TOWN OF BOXFORD

HVAC, Exterior Repairs, Library Renovation
Town Hall/Library
7A Spofford Road
Boxford, MA

ADDENDUM NO. 1 AUGUST 13, 2020

Project No.: 699.1

> SKA-1 Addendum #1

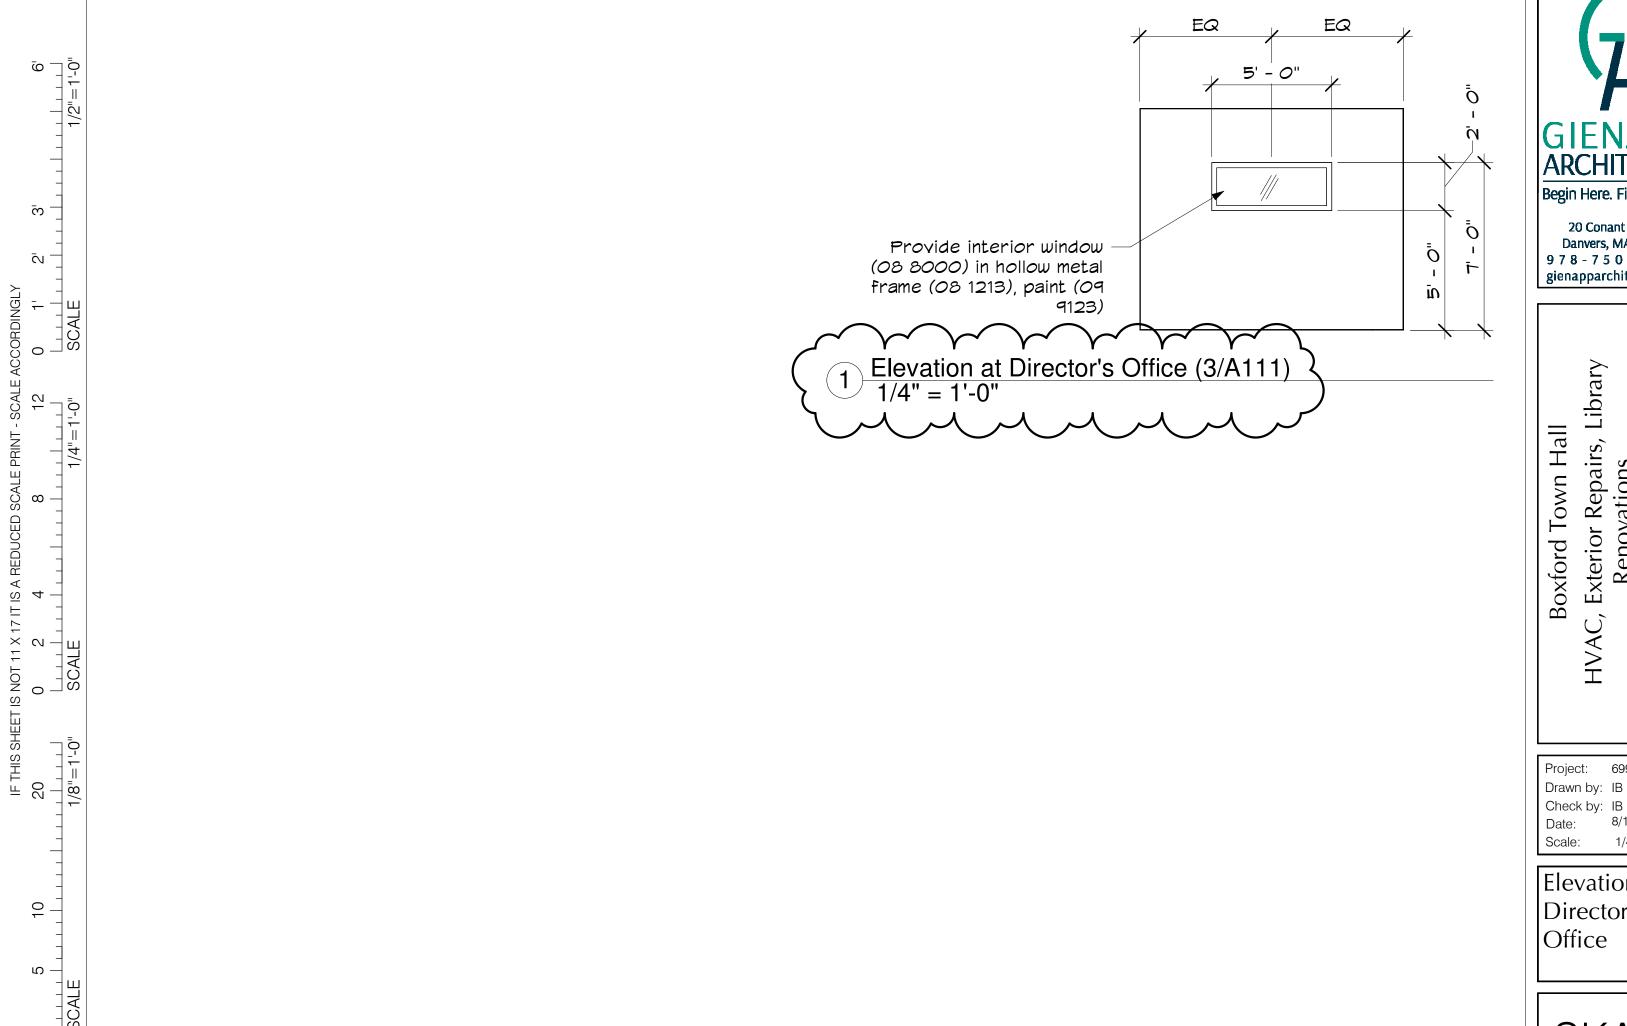
- 2.1. REPLACE detail 2 with enclosed 1/SKA-1 Addendum #1.
- 2.2. REPLACE detail 3 with enclosed 1/SKA-2 Addendum #1.

8/12/2020 As indicated Roof Plan &

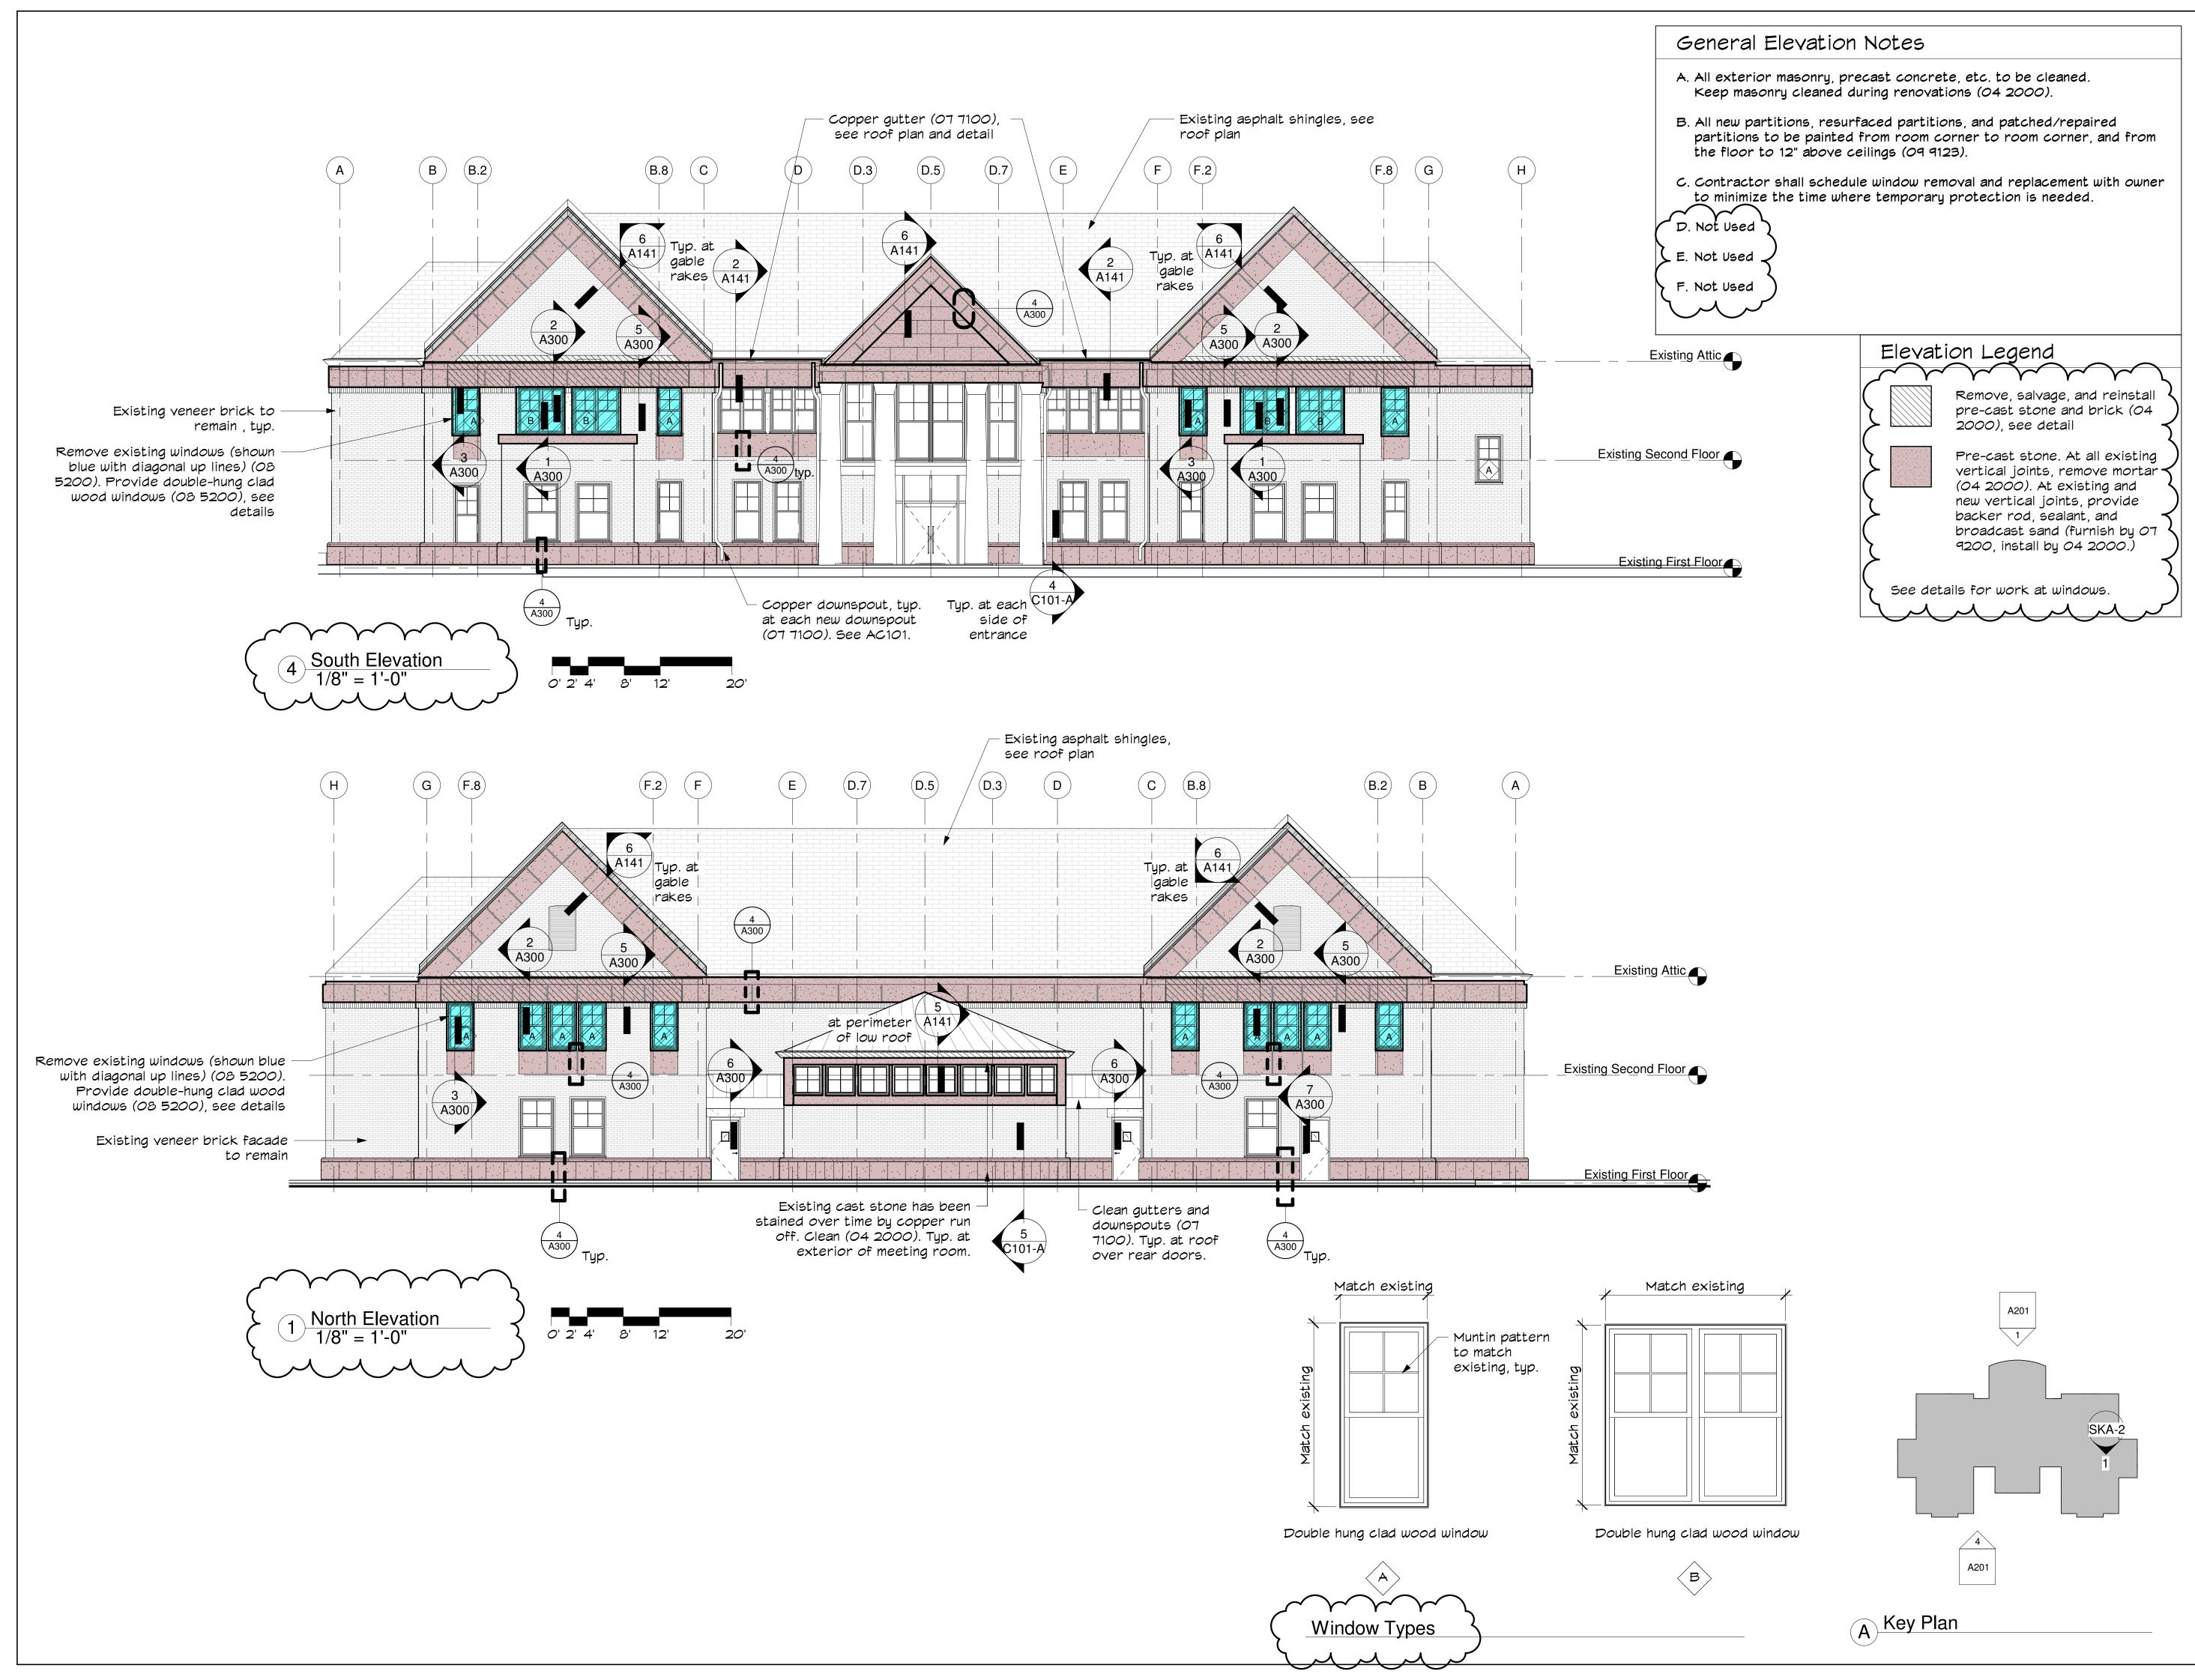
3.1. ADD, REPLACE, and OMIT notes as indicated on enclosed A141.

Exterior Building Details

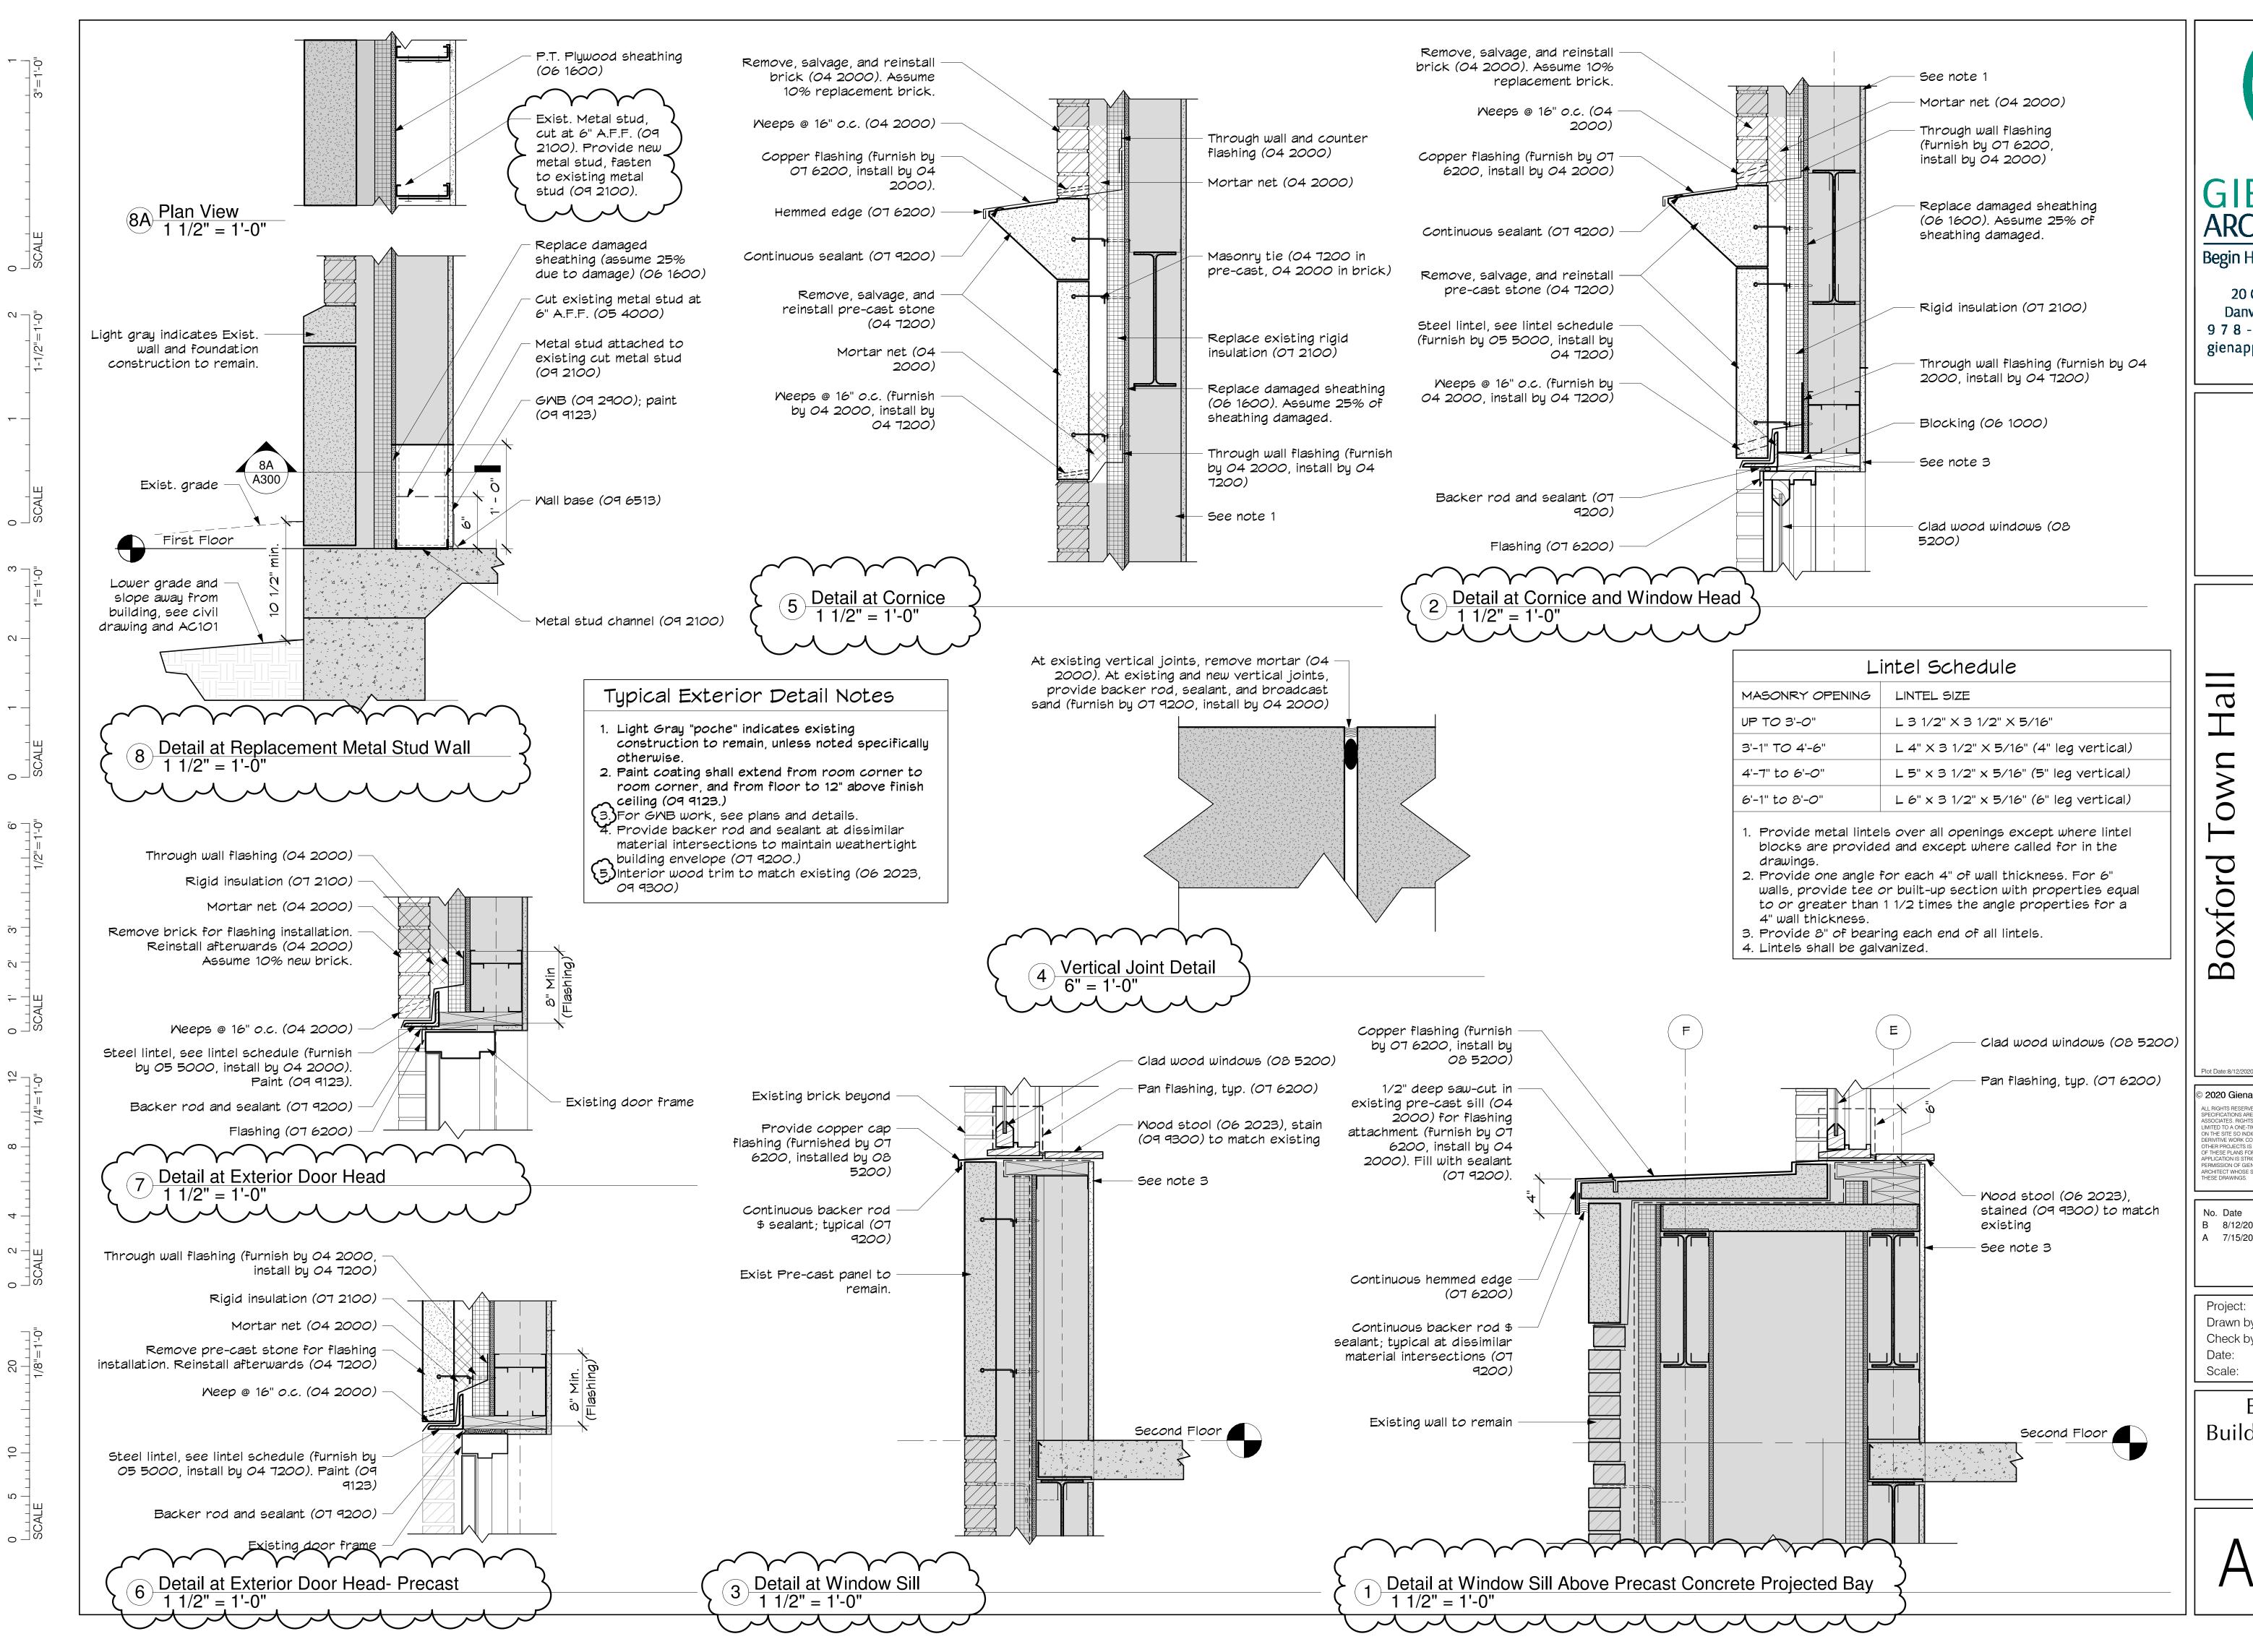
6.1. ADD, REPLACE, and OMIT notes as indicated on enclosed A300.
